# TANDEM plus BLUMOTION 563H/563.

INST-TDM563H.03.12

# TANDEM plus BLUMOTION

## New side adjustment

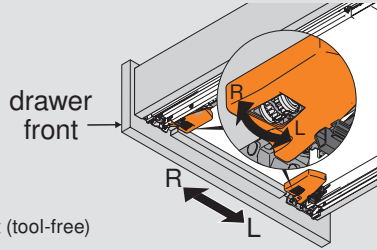
1. Rotate side adjustment left or right equally on both locking devices. Drawer front moves in the same direction as rotation.

Maximum 1.5 (1/16") to left or right (tool-free)

**NOTE:** Side adjustment not available on T51.18xx locking devices

## New rear side adjustment

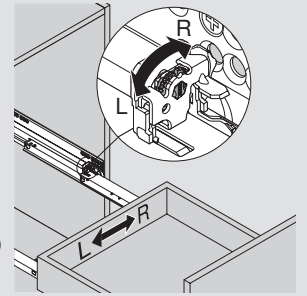
2. After front side adjustment is made with the locking devices, rotate the rear side adjustment left or right to re-align the back of the drawer box with the front. Drawer back moves in the same direction as rotation.

Maximum 1.5 (1/16") to left or right (tool-free)

## New profile setback

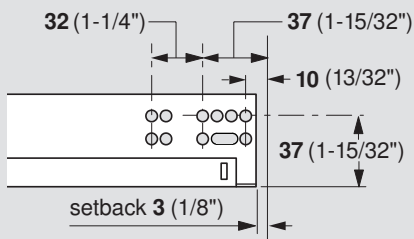
**NOTE:** Hole locations to the face of the cabinet stay the same. For inset applications see the TANDEM brochure

## Drawer preparation

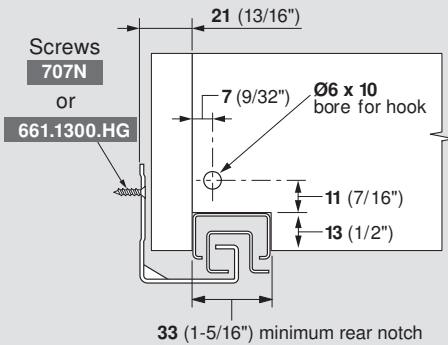
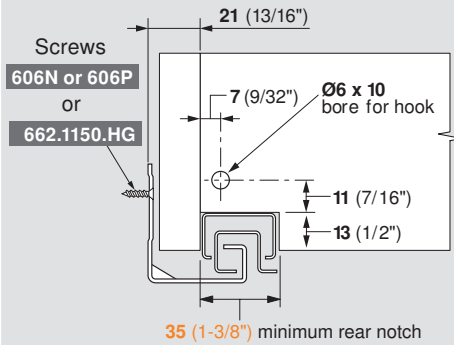
- No change to rear hook hole location, depth or diameter
- Rear notch width changes from **33** (1-5/16") to **35** (1-3/8")
- Mounting screws change from #7 head to #6 head wood or system screws

## Locking devices

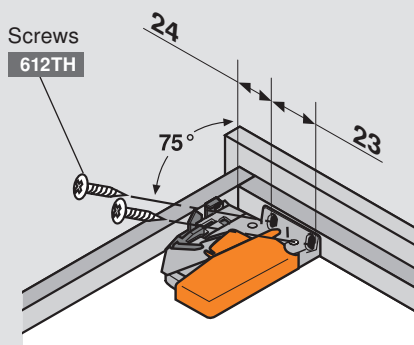
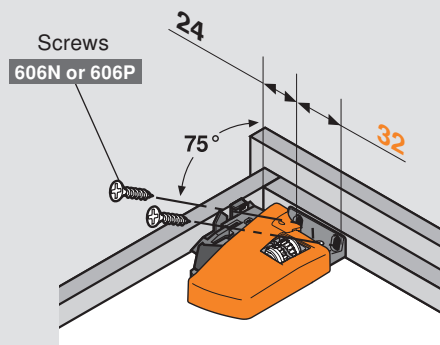
- **9** (11/32") difference in mounting hole location
- Mounting screws change from #6 truss head screws to #6 flat head wood screws

**NOTE:** T51.17xx locking devices cannot be used with new 563 runners. T51.18xx and T51.19xx locking devices cannot be used with 562 runners.

## TANDEM template

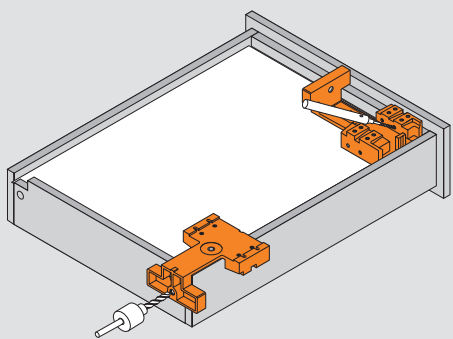
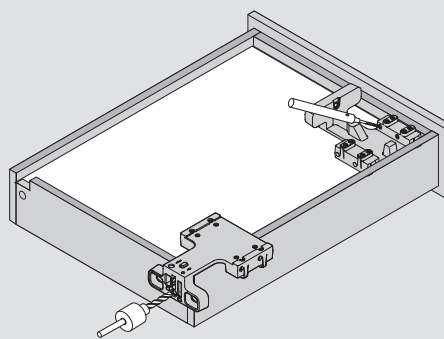
- Color changes from orange to gray
- Hole locations change to accommodate new locking devices
